Confidential  
TECHNICAL SERVICE BULLETIN

NO. 3 D 5

SUBJECT:

Delay in Engagement of Drive

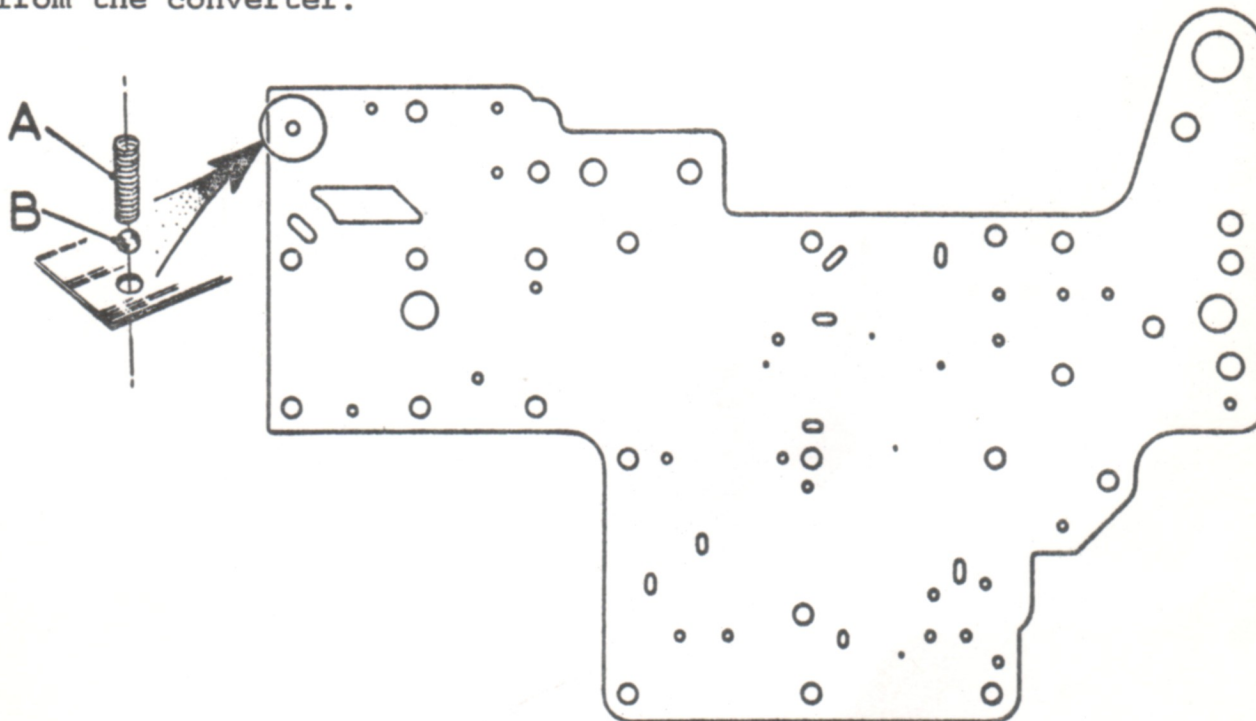
If delay in the engagement of drive is experienced, particularly when starting from cold, it may be caused by wear in hole 'A' in the valve block steel manifold plate, which prevents ball 'B' from seating correctly, allowing oil to drain from the converter.

This condition usually can be ascertained by checking the oil level prior to starting and rechecking after running the engine a few minutes. An appreciable difference in oil levels is usually apparent.

To eliminate this condition, install part number 37H 4647, nylon ball and a new manifold plate, 37H 4139.

Under no circumstances should complete valve block assemblies be replaced for this fault.
